Einsteins V2.4004:  
resonance adventure:  
300 trident machine

Ebb36 v1.2

# Results of Input shaper without toolhead

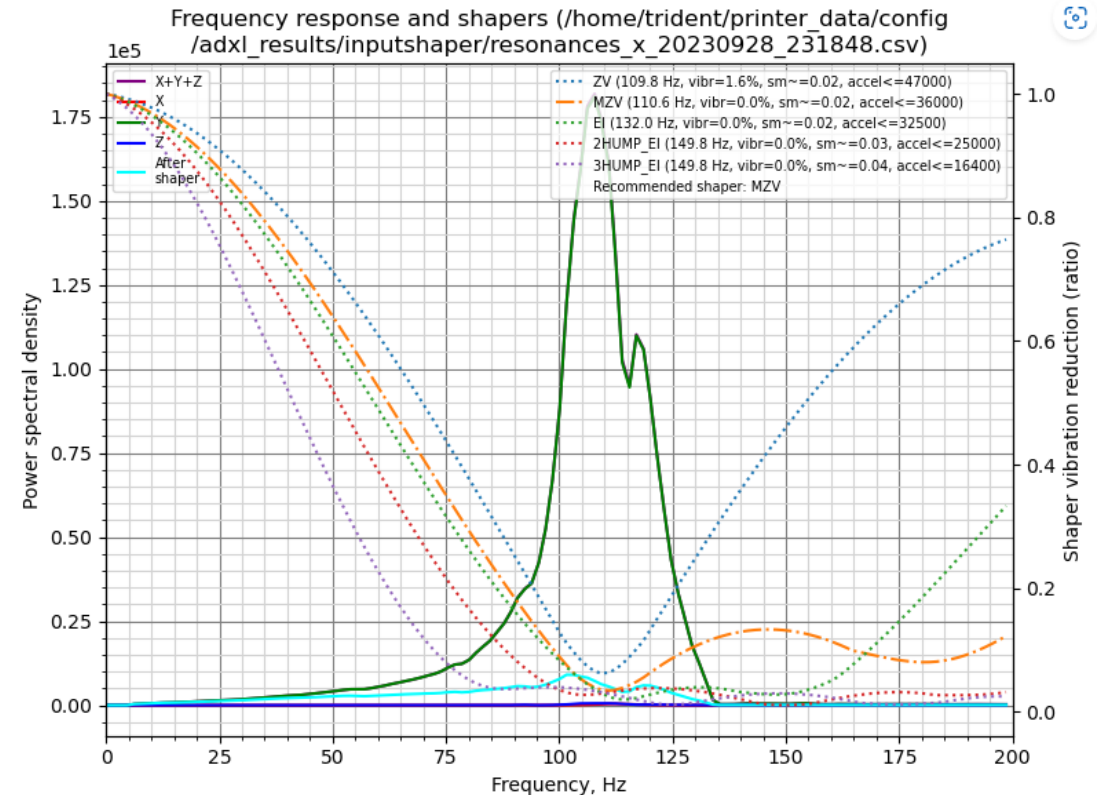
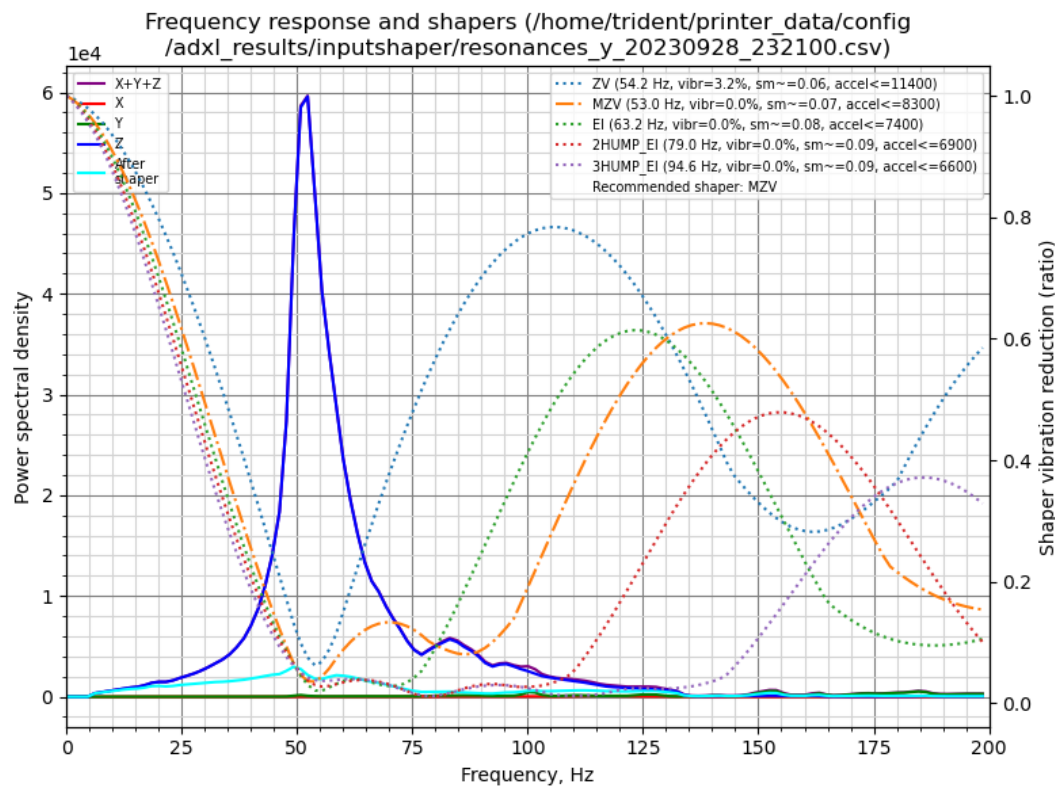
- By putting the adxl directly on the Vitalii tap we have shown through the resulting input shaper graphs that the motion system is solid. We are not getting the 100hz in y.
- What we cannot say is that the x-linear rail is solid. This is because there is no weight on it. However, in the case at hand that is not a real issue as the x-axis input shaper graphs were not an issue.
- Outside testing
  - More testing on this technique needs to happen. This needs to be verified with a known good system. Reth will try to develop a testing platform to determine if this can be a definitive test for testing the motion system to determine toolhead head issue from the rest of the motion system

- What I expect to have happen when the toolhead is reattached is that the main peak of  $x$  will go down due to the weight of the toolhead, and the peak will shift to the left (lower freq). This is also due to the weight of the toolhead.
